501 Charmany Drive
Contract 8166
MUNIS 11847
Developer: University Research Park, Incorporated

ADDENDUM NO. 1:

Re: City Directed Changes to Completed Work
New Intersection at South Whitney Way and Endeavor
Innovation One / Exact Sciences & University Research Park

Subject: Whitney Way Turn Lane Redesign &
Construction

UNIVERSITY RESEARCH PARK/ INNOVATION ONE; PROJECT NO. 11847	SHEET NO. D-2
DETAILS	
TYPICAL SECTIONS	CITY OF MADISON

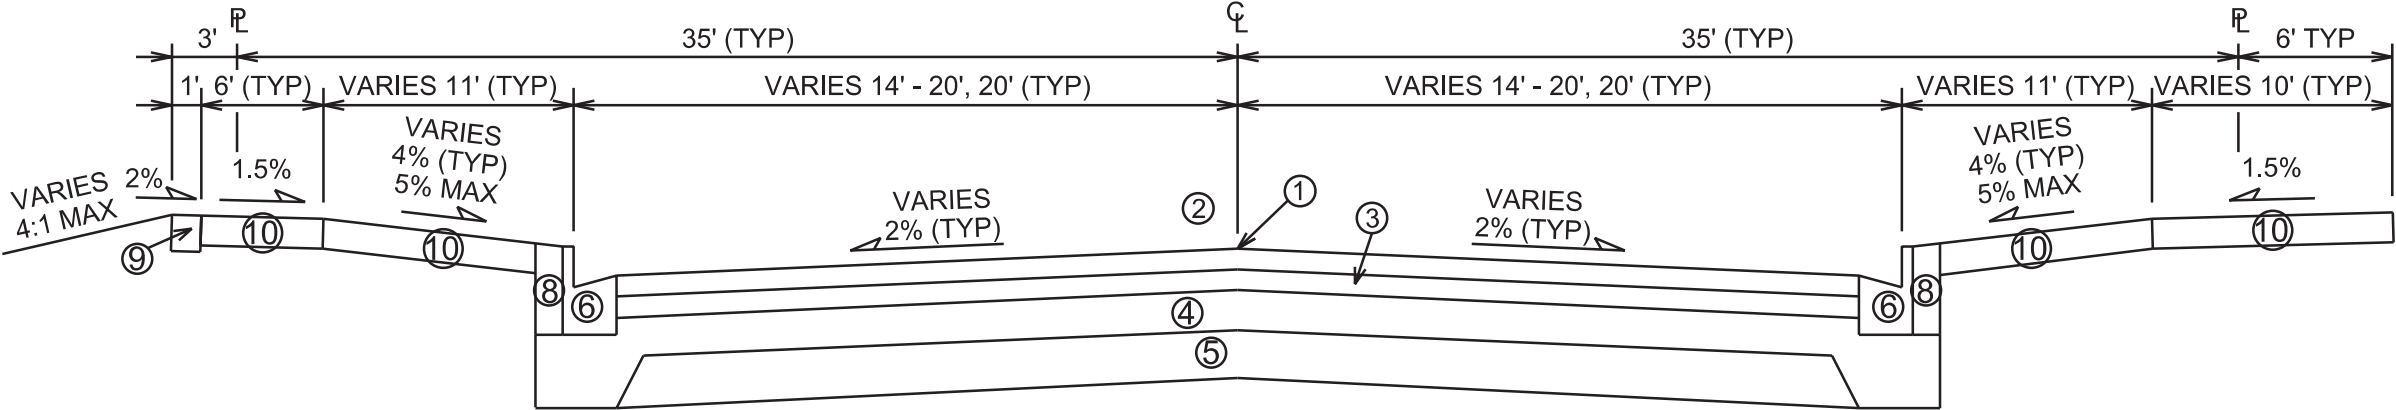
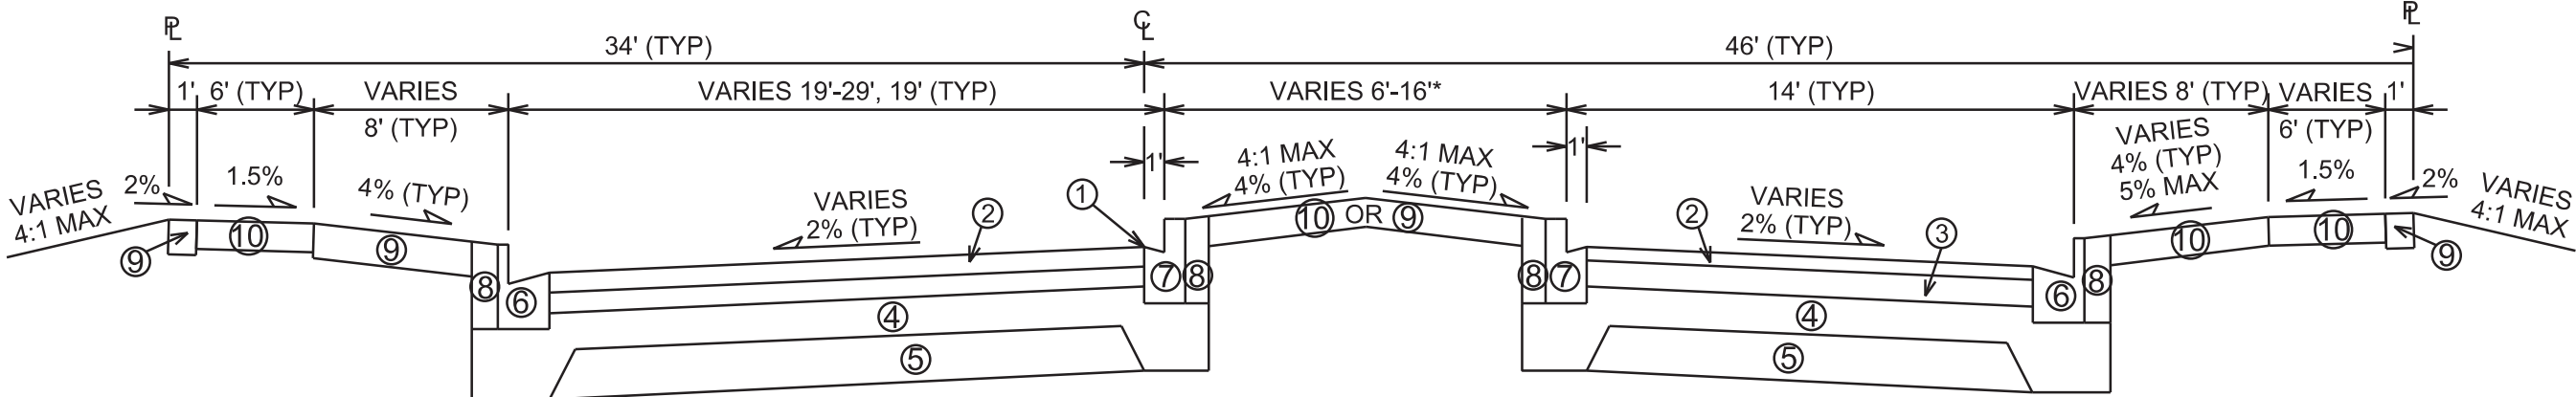
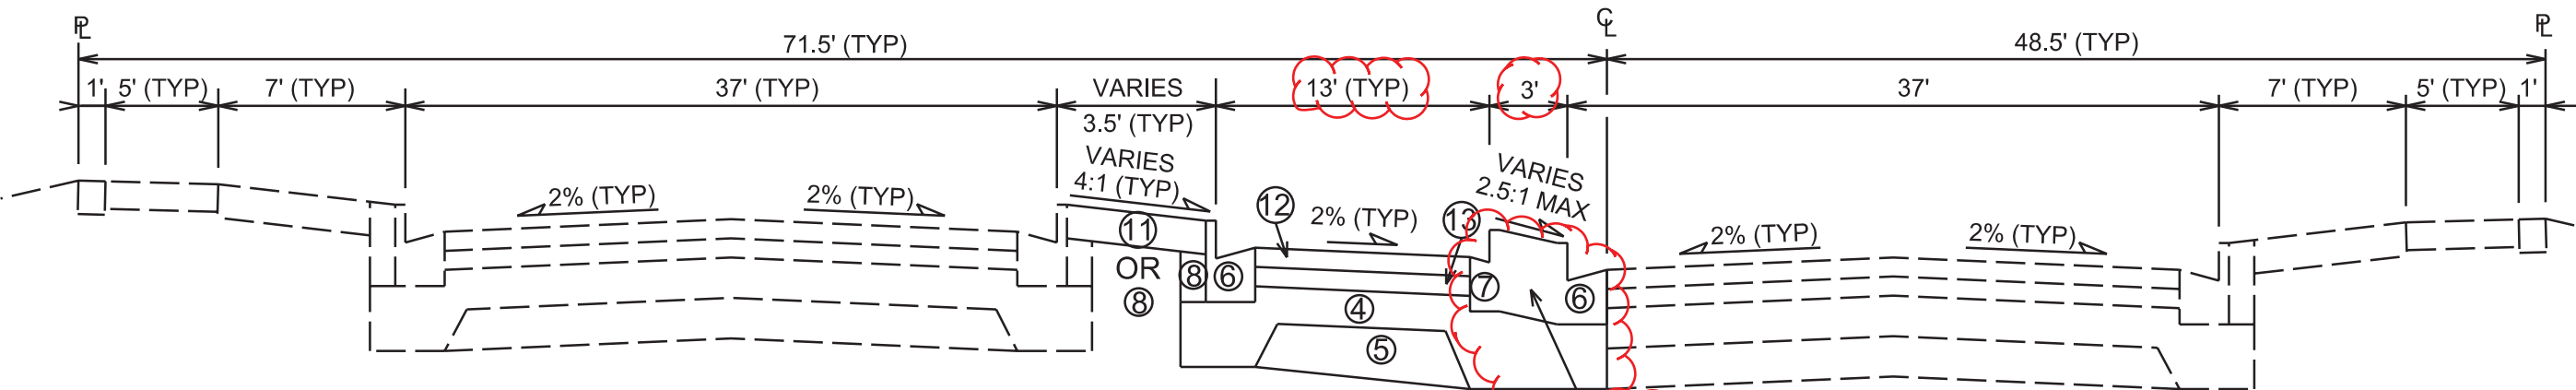
- Based on standard 6-bag 4,000 psi concrete mix design during normal business hours Monday - Friday.
- Color hardener is not included.
- No monolithic pouring of curb sections as shown on D-2.

REVISION 6/20/19 AJZ
- Whitney Way typical

POUR CURB & GUTTER AND
TERRACE BETWEEN
AS MONOLITHIC

- On June 26, 2019 the City approved via email to Derek Burdick of Findorff that the South Whitney Way north bound left turn lane median C&G does not have to be a single pour of concrete.

UNIVERSITY RESEARCH PARK/ INNOVATION ONE	SHEET NO. U-4
STORM SEWER SCHEDULE	
PROJ #11847	CITY OF MADISON

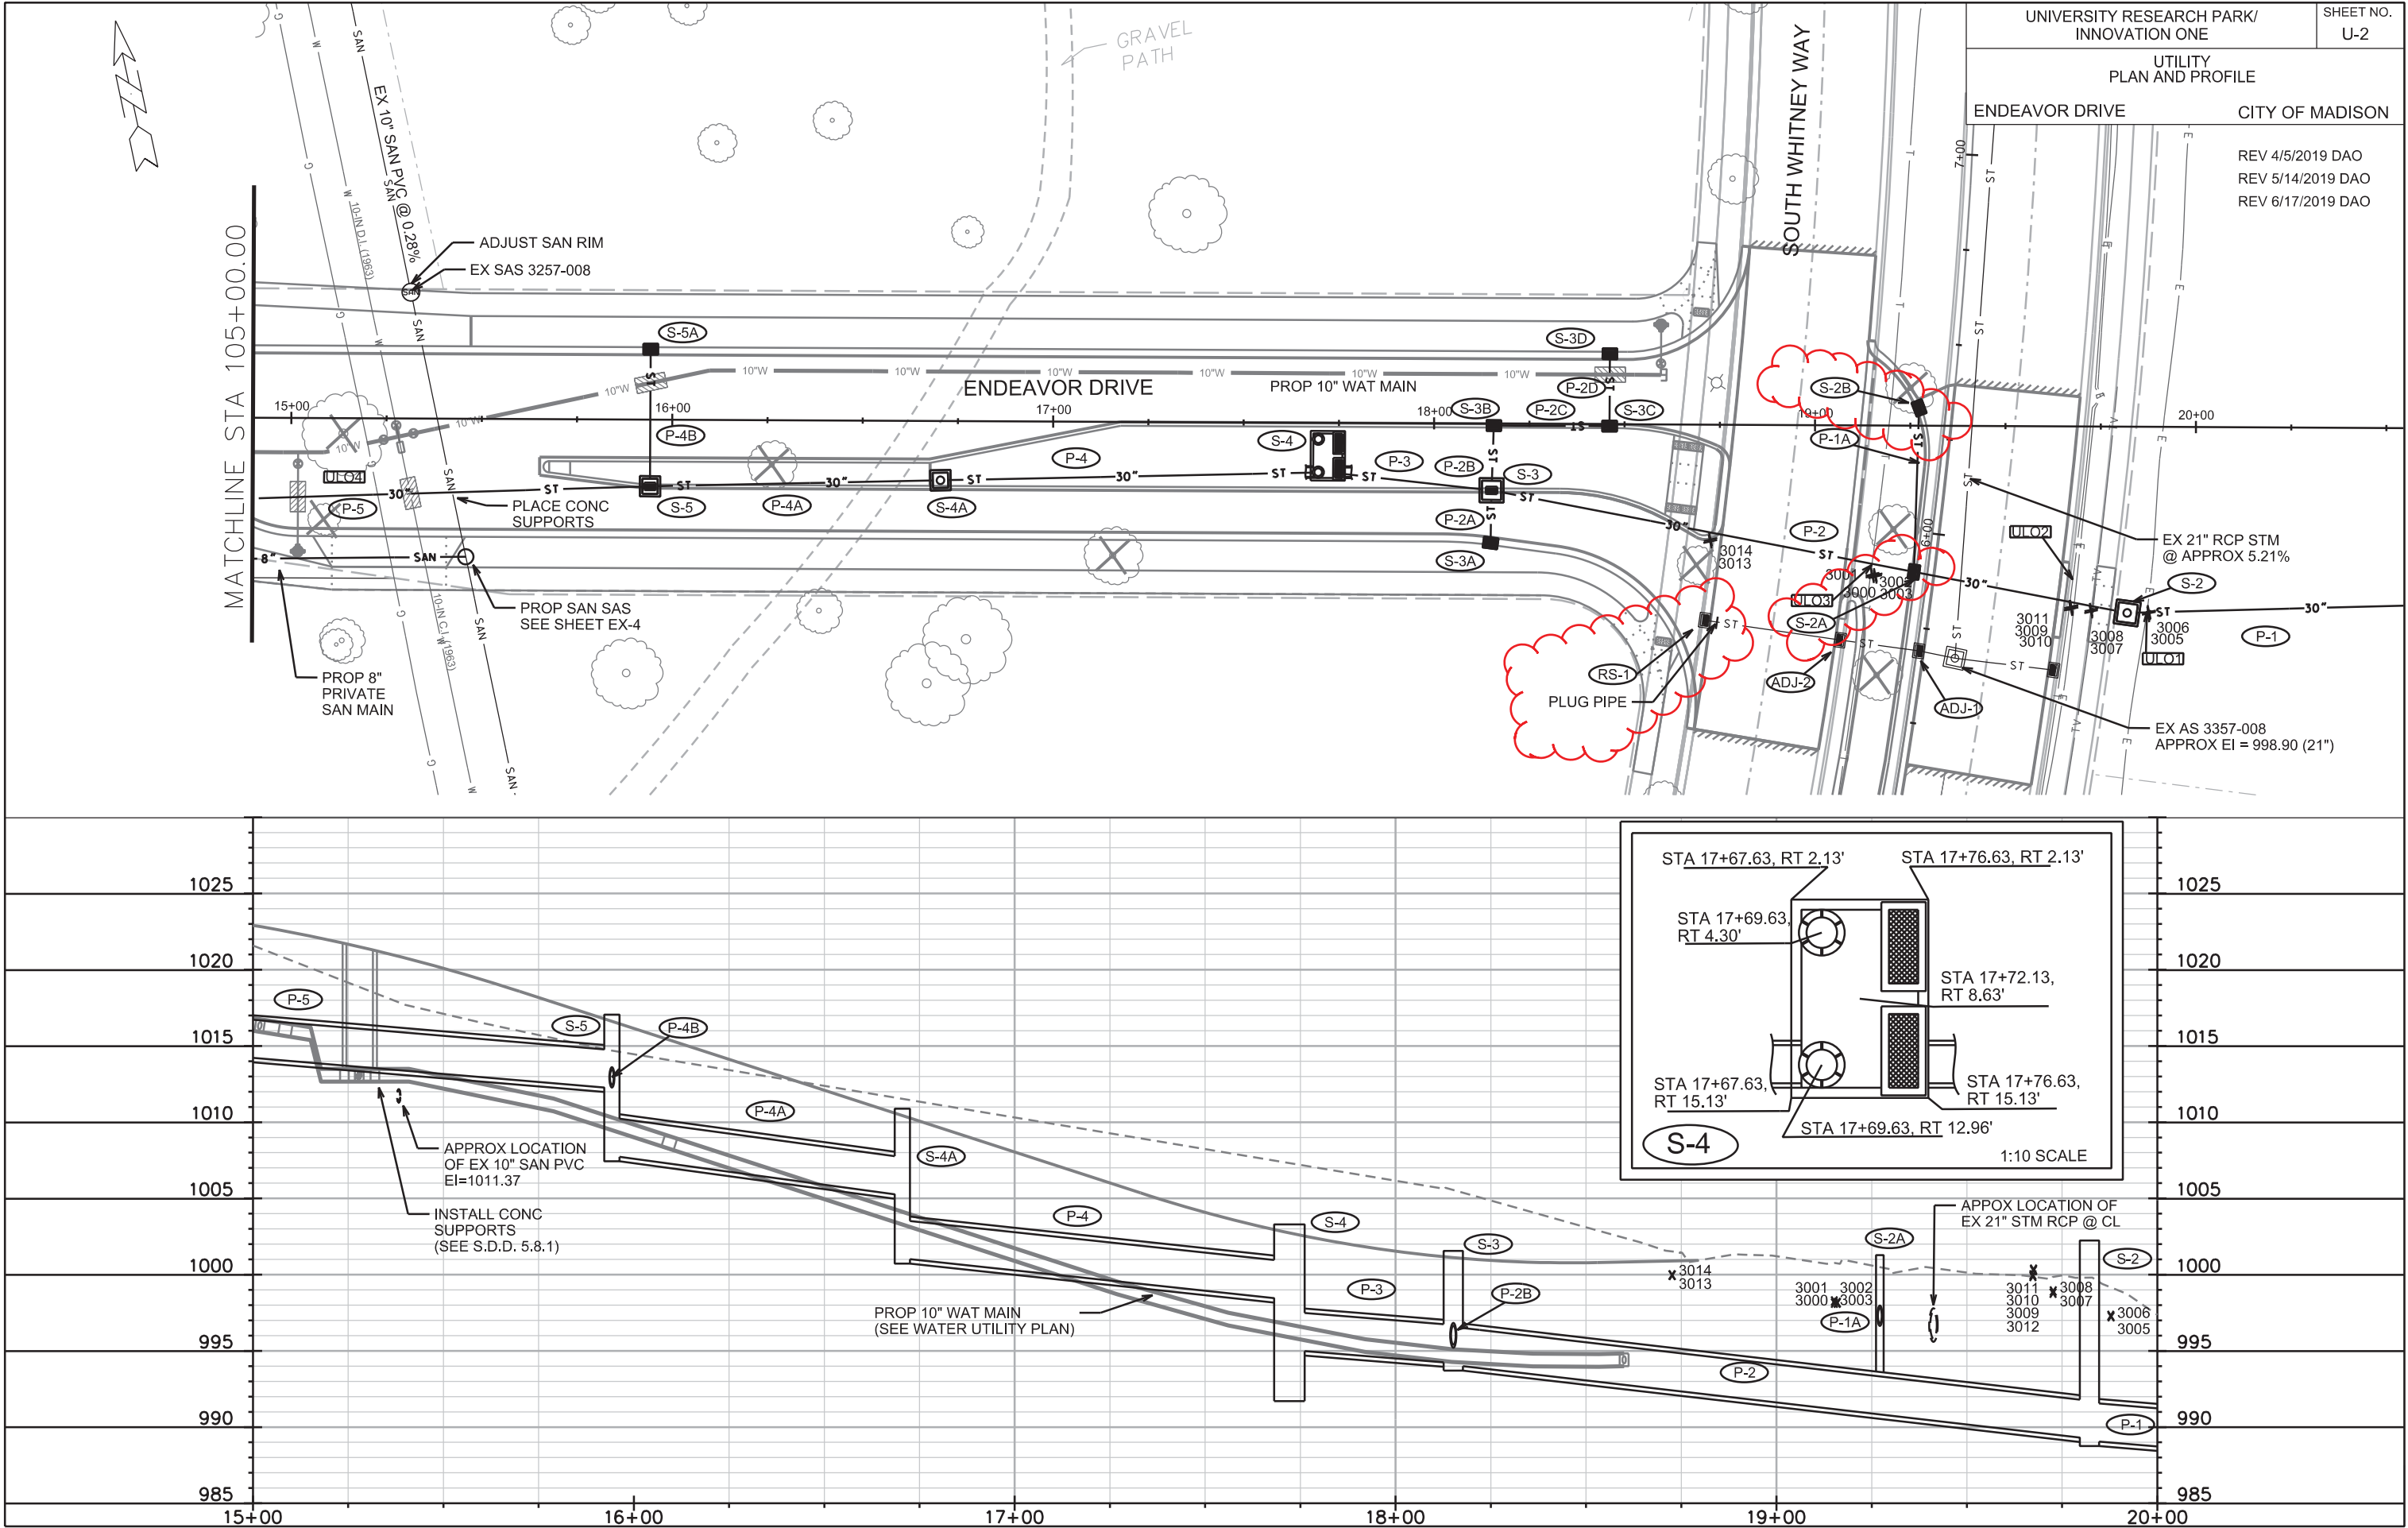
* REV 5/14/2019 DAO
** REV 6/17/2019 DAO

ADJ-1	IN 3357-011	5+68.98	LT-1.26	1002.45	1002.44	-0.01	
ADJ-2	IN 3357-010	5+68.88	LT-21.55	1003.69	1003.03	-0.66	
** ADJ-3	IN 3357-009	5+69.00	LT-58.02	1003.27	1003.30	0.03	(4) TO BE REMOVED (RS-1)
** RS-1	IN 3357-009	5+69.00	LT-58.02				PLUG PIPE

- R.G. Huston Company Inc. listed an inlet removal, 48" precast manhole, a pipe plug, and pipe collars that are not within the South Whitney Way left turn lane. The City will not pay for those items. The City will pay for the earthwork associated with the South Whitney Way left turn lane C&G removal and replacement.
